Report FL #: 10088 for Greenheck models EHH-601D & ESD-635D (both w/ and w/o VCD-40 Damper)

Report FL #: 10093 for Airolite models SCH601MD & K6746MD (both w/ and w/o VCD-40 Damper)

APPROVAL DOCUMENT: Drawing No. **K6746MD**, titled "K6746MD Louver", sheets 1 through 37 of 37, dated 08/09/2017, prepared by The Airolite Company, signed and sealed by Wayne K. Helmila, P.E. on 08/19/2024 and 09/27/2024, bearing the Miami-Dade County Product Control revision stamp with the Notice of Acceptance number and expiration date by the Miami-Dade County Product Control Section.

PRODUCT REVISED
as complying with the Florida
Building Code
NOA-No. **24-0930.05**
Expiration Date **12/06/2029**

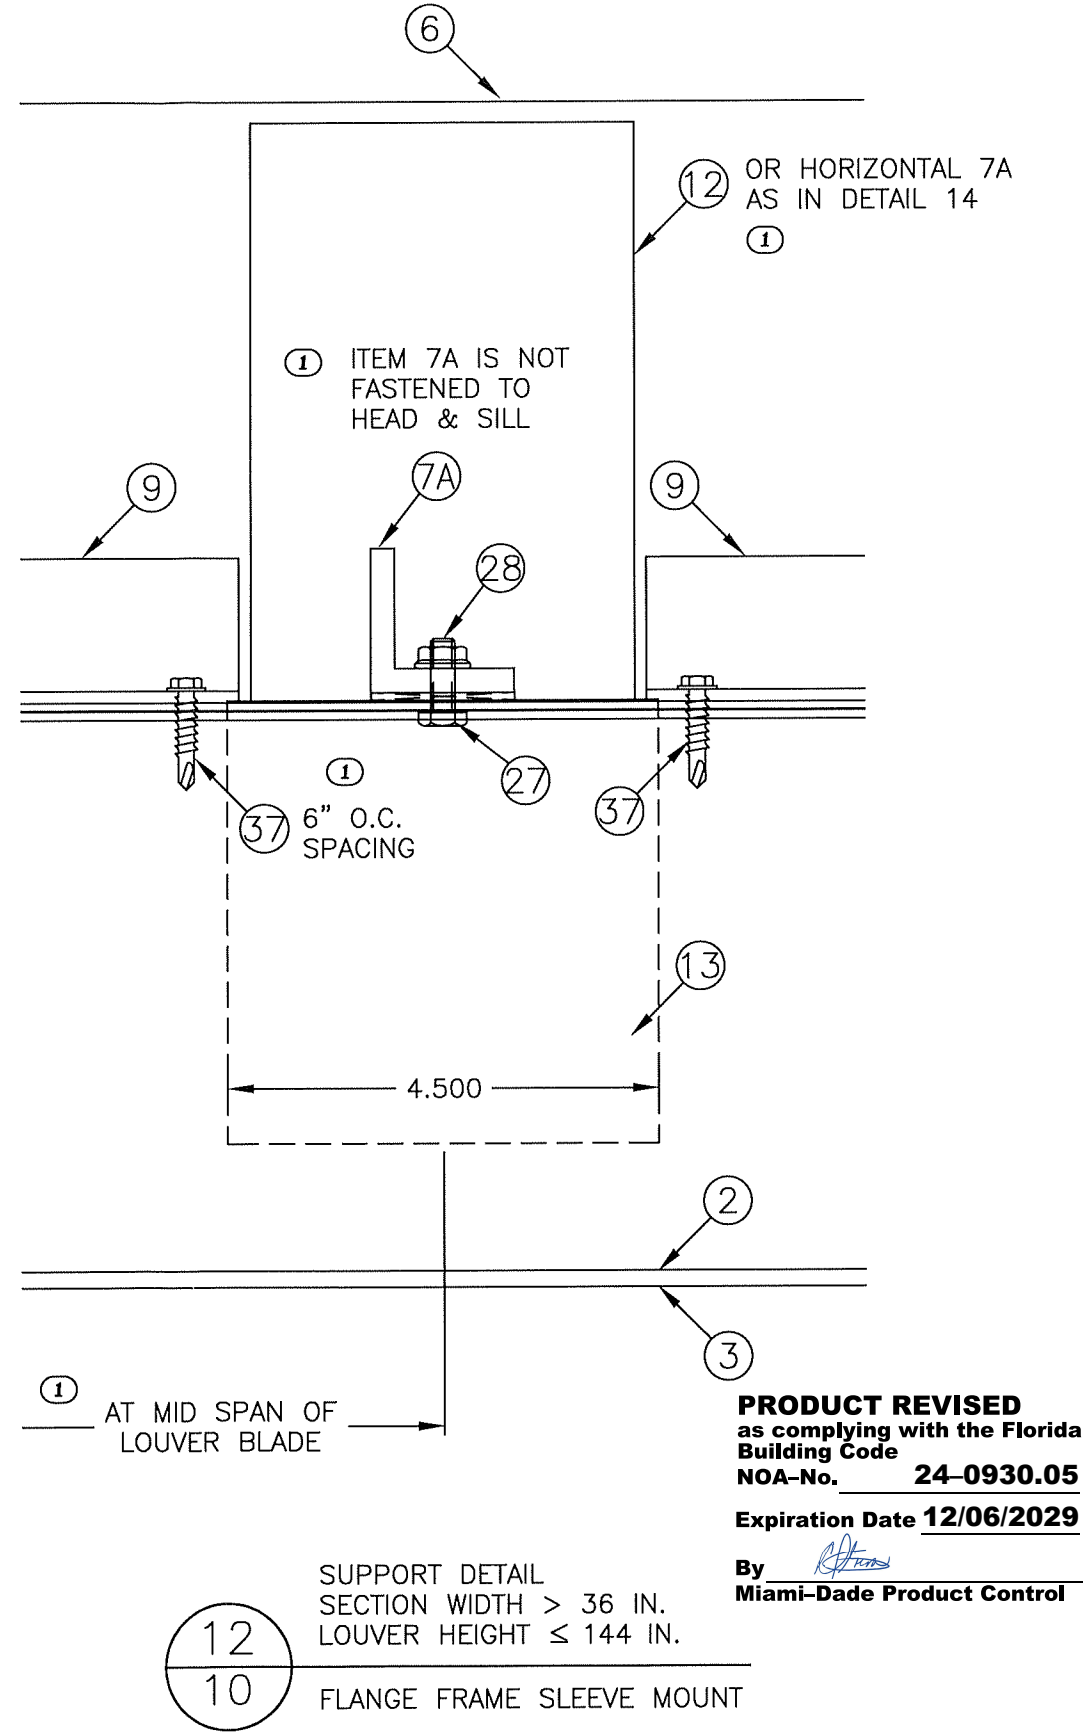
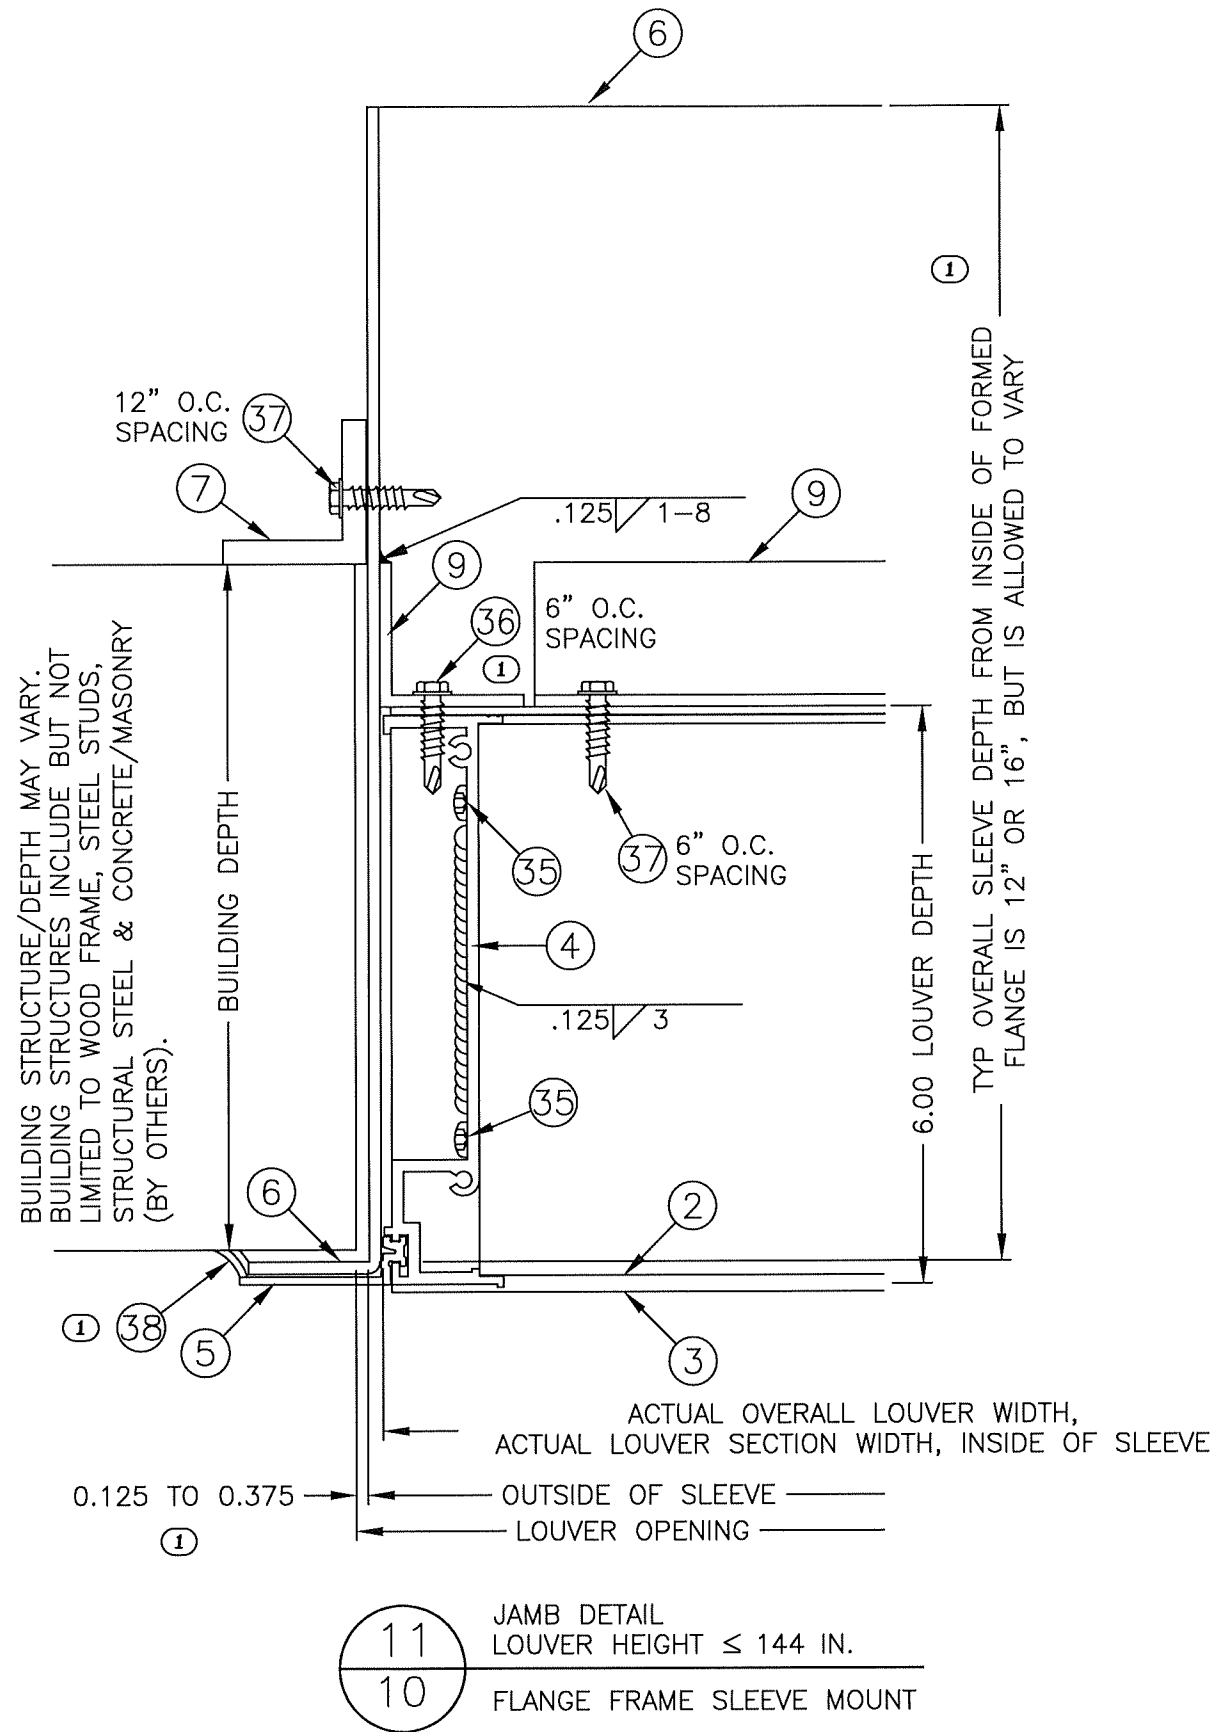
REV 01: 9/25/23, WAS PAGE 8, COMBINED DETAILS 9A & 9B INTO ONE DETAIL 9, ITEMS 27 & 28
NOW THE ONLY FASTENER OPTION FOR THE NON-WELDED OPTIONS OF DETAIL 10, & ADDED 7A NOTE.

REV 01: 8/1/24, WAS PAGE 9, REMOVED DETAIL 12B, ADDED SLEEVE & LOUVER DEPTH DIMS, REPLACED ITEM 37 WITH ITEM 36, ADDED ITEM 7A OPTION, ADDED ON CENTER, ADDED ITEM 7 NOTE, ADDED ITEM 38, ADDED MID SPAN DIM, & REMOVED "TYP" FROM EDGE GAP.

AIROLITE SCHOFIELD, WISCONSIN 54476 715-359-6171	DRAWN BY	DATE
	MES	8/9/2017
TITLE K6746MD LOUVER CONTINUOUS ANGLE MOUNT JAMB & SUPPORT DETAILS HS144"	SCALE	SHEET NO.
		11 OF 37
CAD DRAWING NO. K6746MD

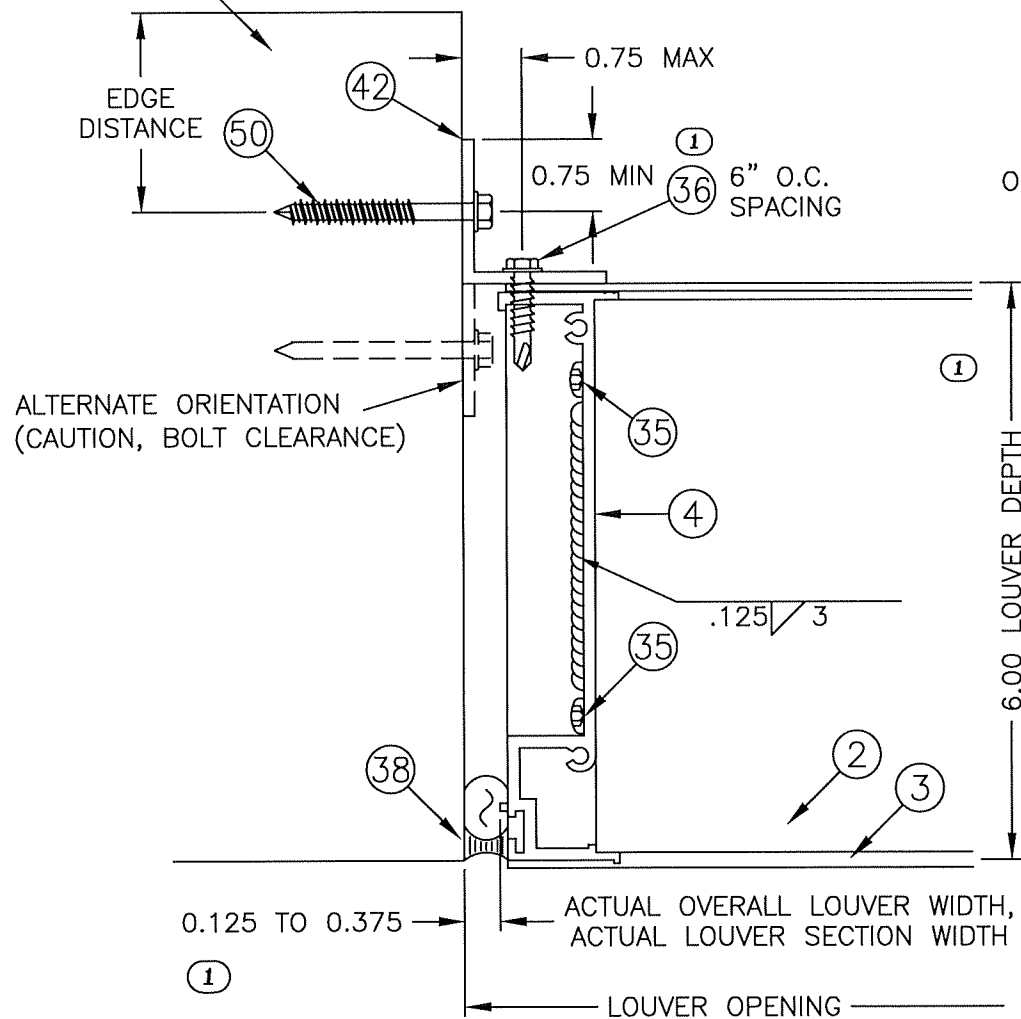
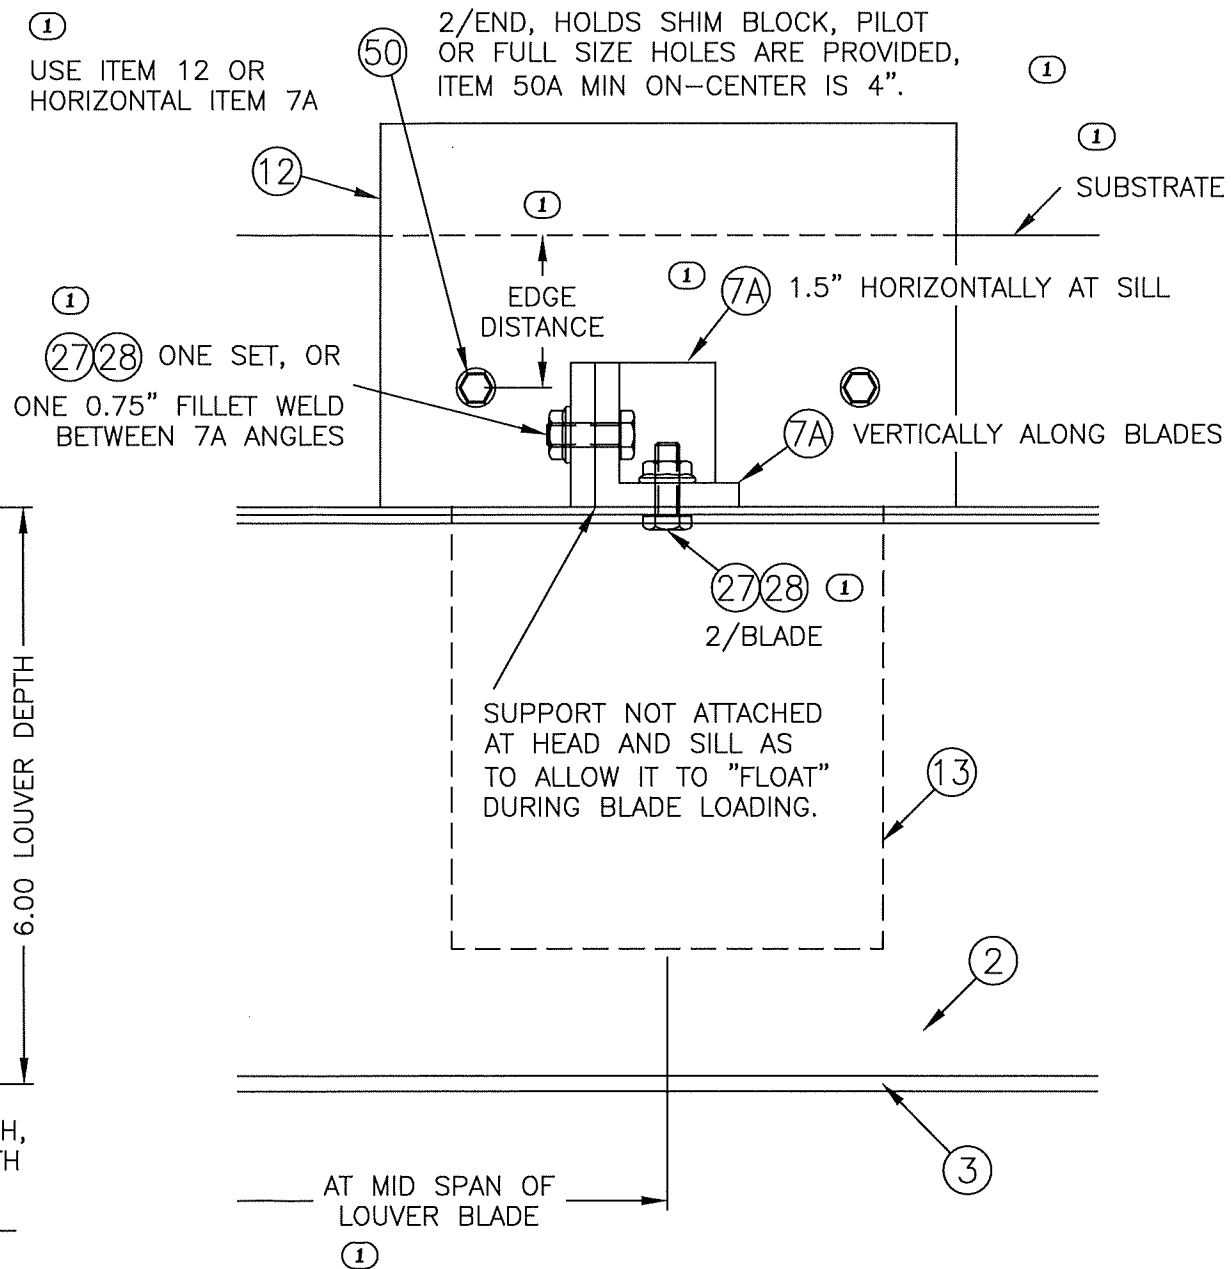
REV 01: 8/1/24, WAS PAGE 10, REMOVED DETAIL 14B, REPLACED ITEM 37 WITH ITEM 36, ADDED ITEM 7A HORIZONTAL OPTION & FASTENING, ADDED DEPTH & EDGE & MID SPAN DIMS, ADDED SUBSTRATE, ADDED ITEM 50A NOTE, CLARIFIED NUMBER OF BOLTS, & REMOVED "TYP" FROM EDGE GAP.

DRAWN BY MES	DATE 8/9/2017	 SCHOFIELD, WISCONSIN 54476 715-359-6171	SCALE	SHEET NO. 12 OF 37	K6746MD LOUVER FLANGE FRAME SLEEVE MOUNT MULLION DETAILS H≤144" & H≤96"
				CAD DRAWING NO.	
					K6746MD

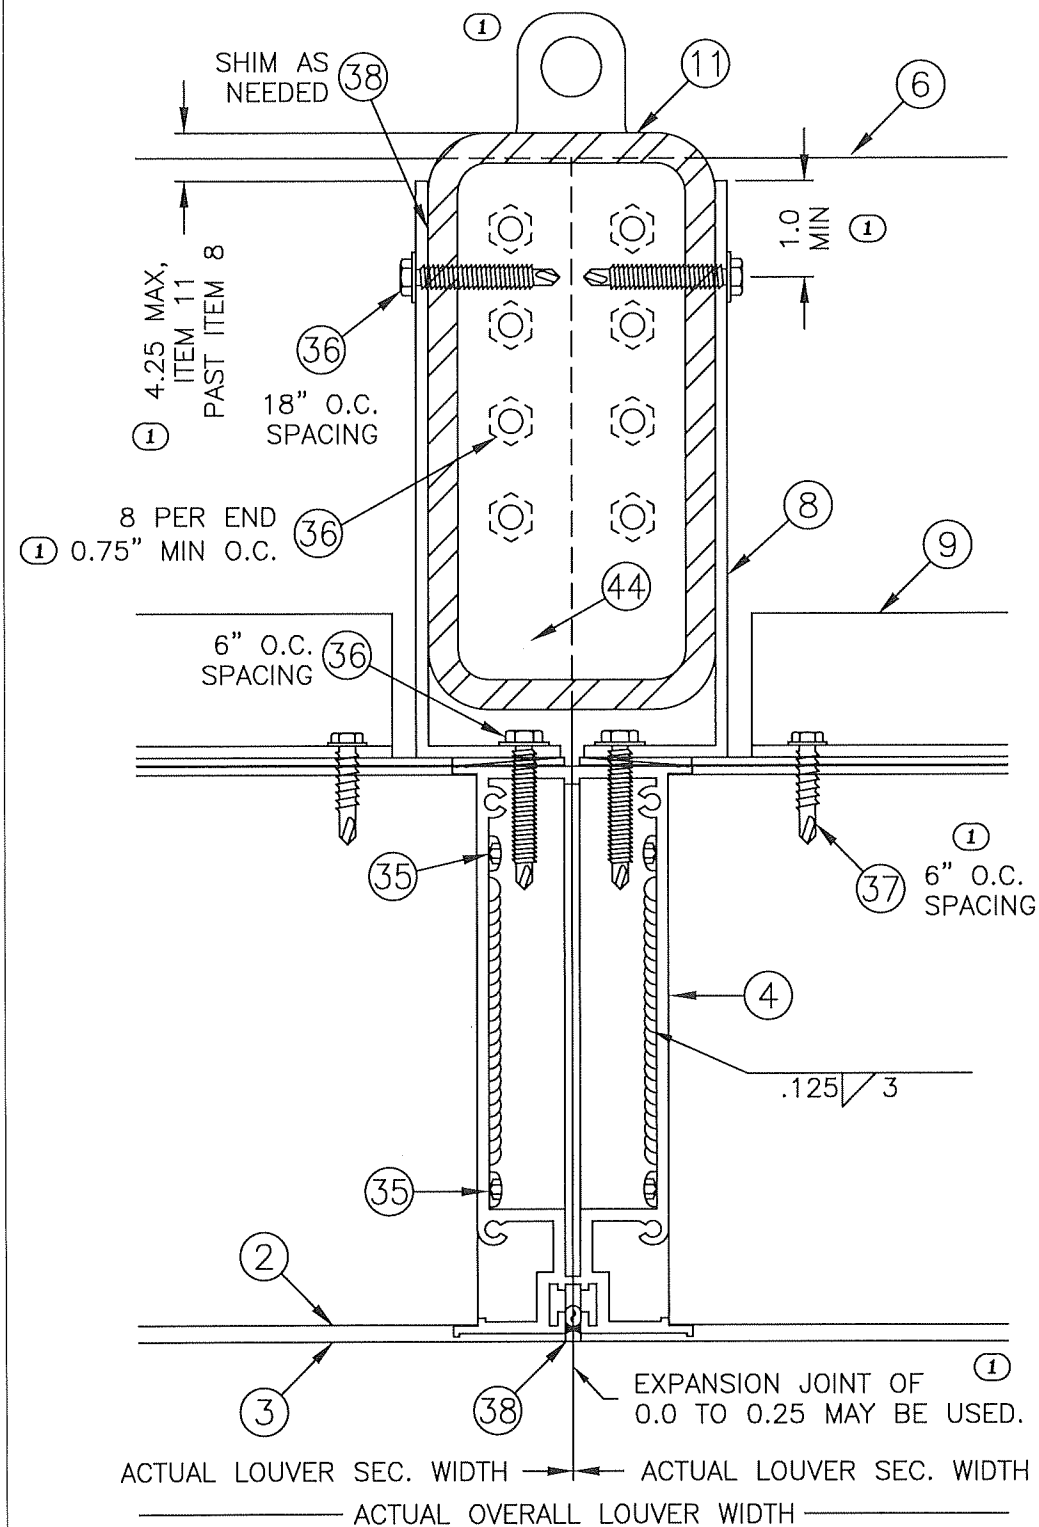
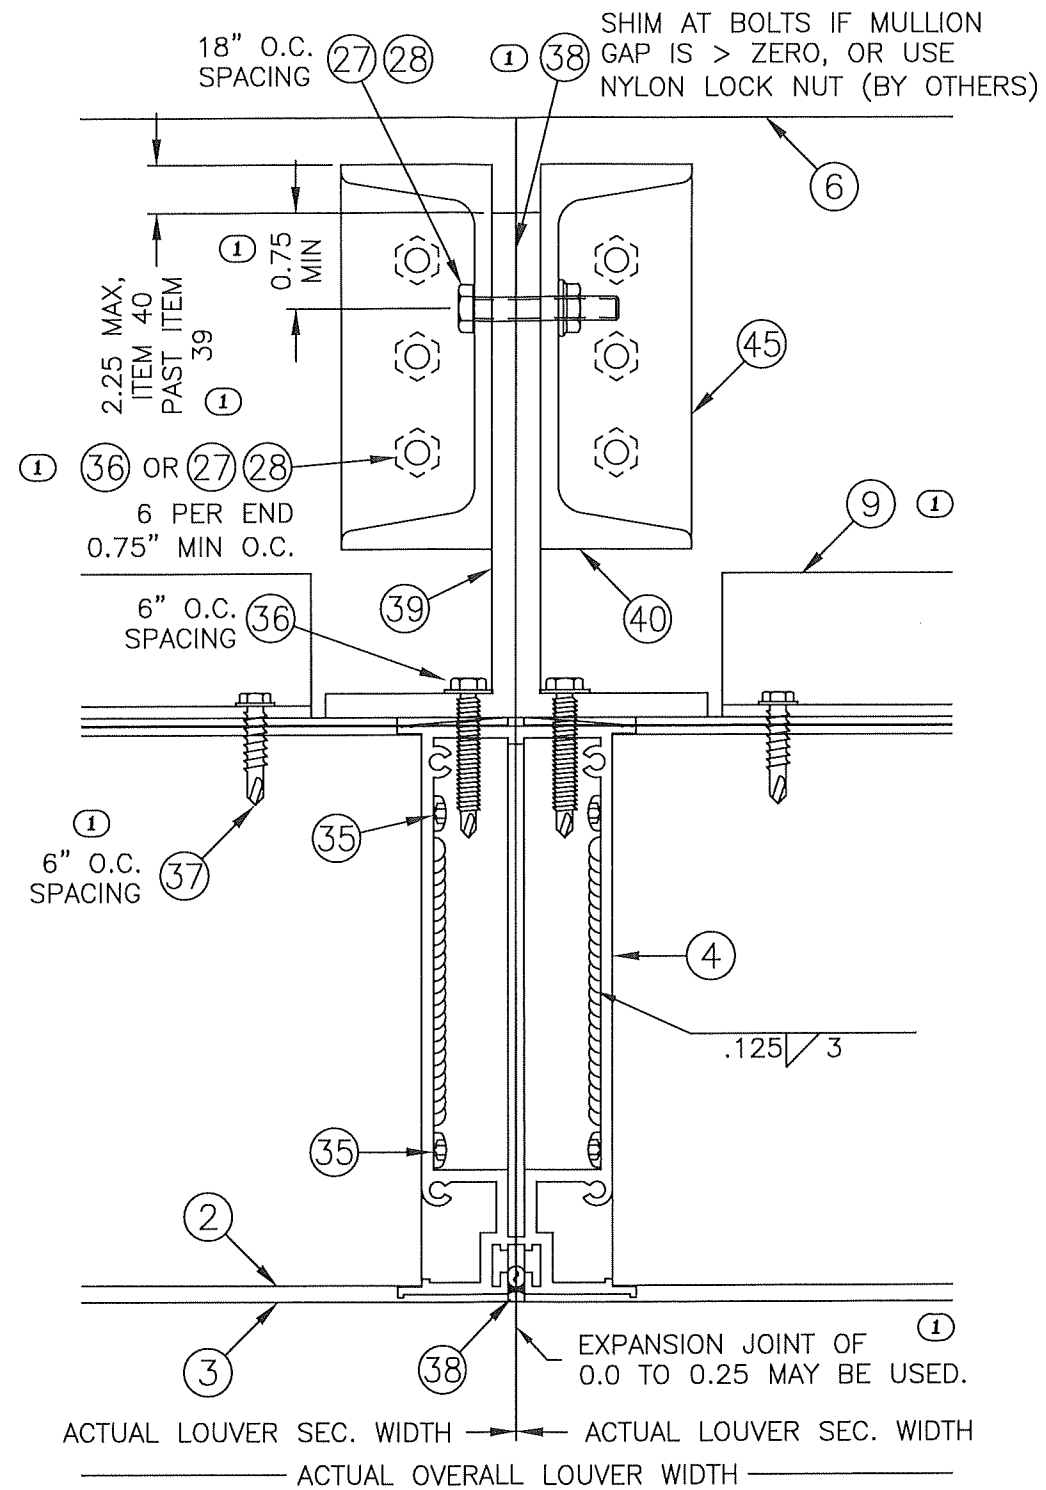
REV 01: 8/1/24, WAS PAGE 11, ADDED LIFTING LUG, REDEFINED ITEM 11 & 40 MAX OFFSETS, ADDED 0.75 & 1.0 MIN OFFSETS, ADDED ITEM 38 CALLOUT, ADDED ON CENTERS OF 6" X2 & 0.75" X1, ADDED ITEM 9 CALLOUT, ADDED ITEM 27/28 CALLOUT WITH ITEM 36 OPTION, & REWORDED MULLION GAP NOTE X2.
